Access Compliance Report Public Rights-of-Way (Curb Ramps)

Intersection ID: 10018631 Main Street: AGAVA LN **Cross Street: N/A** Location: NE ADA ID: CAFC1F5CC720 Ramp Type: BlendTrans1 Initial Pass/Fail: Fail **Overall Compliance: No Severity Score:** 12.5

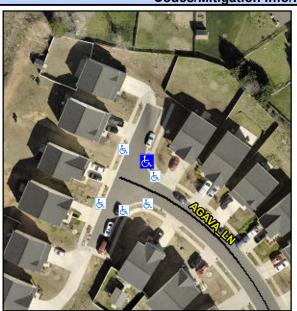
AGAVA LN Street 1 Name Stop Condition-Street 1 None Street 2 Name N/A Stop Condition-Street 2 N/A Possible Solutions: Remove & Replace Curb Ramp With Two New Directional Ramps or Equivalent. Surveyor Notes: N/A PROW/ADA: Not Found, R304.5.3

Compliance Description		Data	Comp	liance Description	Data
N/A	Ramp Length (in)	47.0	Yes	BlendTrans Slope (%)	2.5
Yes	Ramp Width (in)	48.0	No	BlendTrans XSlope (%)	5.8
N/A	Flare Type LT	N/A	N/A	Flare Type RT	N/A
N/A	Flare Slope LT (%)	N/A	N/A	Flare Slope RT (%)	N/A
N/A	Flare Traversable LT?	N/A	N/A	Flare Traversable RT?	N/A
N/A	Landing Length (in)	N/A	N/A	DWS Provided?	N/A
N/A	Landing Width (in)	N/A	N/A	DWS Contrast?	N/A
N/A	Landing Slope (%)	N/A	N/A	DWS Length (in)	N/A
N/A	Landing X Slope (%)	N/A	N/A	DWS Full Width?	N/A
N/A	Landing Curb? (Y/N)	N/A	N/A	DWS Offset (in)	N/A
N/A	Shared Landing?	N/A			
N/A	Gutter Ponding?	N/A	N/A	Gutter Slope (%)	N/A
N/A	Gutter Lip Ht (in)	N/A	N/A	Gutter X Slope (%)	N/A
N/A	Painted X Walk1?	No	N/A	Painted X Walk2?	N/A
	X Walk 1 Direction	To W		X Walk 2 Direction	N/A
	X Walk 1 Width (in)	N/A		X Walk 2 Width (in)	N/A
	X Walk 1 Slope (%)	1.2		X Walk 2 Slope (%)	N/A
	X Walk 1 X Slope (%)	5.5		X Walk 2 X Slope (%)	N/A

N/A	Ramp inside XWalk1?	N/A	N/A	Ramp inside XWalk2?	N/A
	Road Slope (%)	5.5		Clear Space?	N/A
	Road X Slope (%)	1.2	N/A	Clear Space to XWalk (in)	N/A
N/A	Any Obstructions?	N/A	N/A	Storm Grate/Utility Hazard?	N/A
	Obstruction Type			Storm Grate/Utility Type	
		N/A			N/A
			Yes	Surface Condition? (G/P)	Good
			No	Curb Slope (%)	11.8
